Docket Item # 6
BAR CASE # 2008-0242

BAR Meeting
February 18, 2009

ISSUE: Alterations
APPLICANT: Virginia Magestic for Bob and Rebecca Sutton
LOCATION: 713 South Pitt Street
ZONE: RM/Residential

Figure 11: Rear portico elevations and specifications submitted for 2/4/2009 OHAD hearing.

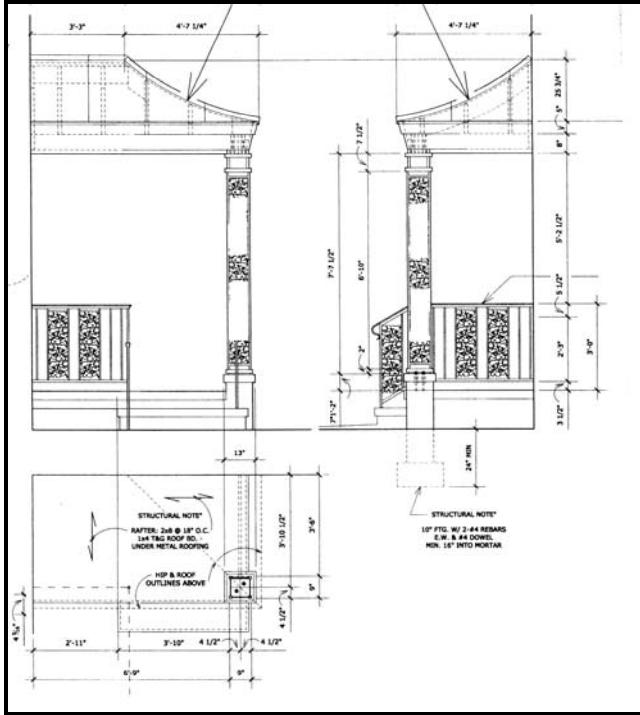
The rear portico will have a flared copper roof and will be installed over the existing stoop. The roof will measure 7' 10 ¼" wide and will project 4' 7 ¼" from the building façade. The same decorative square columns supporting the roof are proposed for the rear elevation.

Staff does not object to the style of the proposed front portico because 713 South Pitt Street, as well as many of the townhouses in the Yates Garden development, does not reflect one specific architectural style. However, Staff does object to the use of Azek (plastic) trim on the porticos. The *Design Guidelines* recommend that porches (and porticos), railings and stoops be constructed of materials which are sympathetic to the building materials generally found in the historic districts. In the opinion of Staff, the trim on porticos should be constructed of wood.

1. That the open iron columns are two sided and not four sided;
2. That the floral pattern encompass the entire height and both sides of the two sided column; and,
3. That the trim on the porticos be constructed of wood and not Azek.

Figure 14: Detail of proposed front portico.

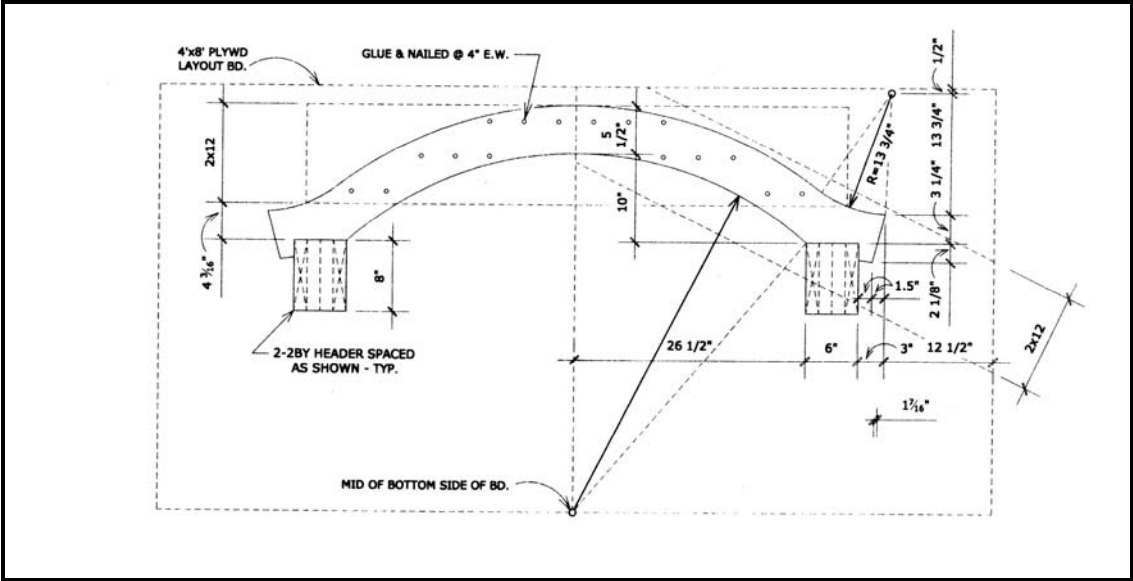
The applicant proposes to install a new portico with decorative open iron columns over the existing front stoop. The proposed new arched roof portico will measure 6' 4 ½" wide and will project 3' 8 ¾" from the front building wall. The roof of the portico will be clad with standing seam copper. The existing shutters on either side of the front door will be removed and the existing light fixture above the front entrance will be relocated to the south side of the door. The decorative columns will be constructed of open ironwork and will measure 9" on each side. The columns will have the same floral pattern as the existing railing ironwork but in three sections on the vertical column – at the top, in the middle and at the base.
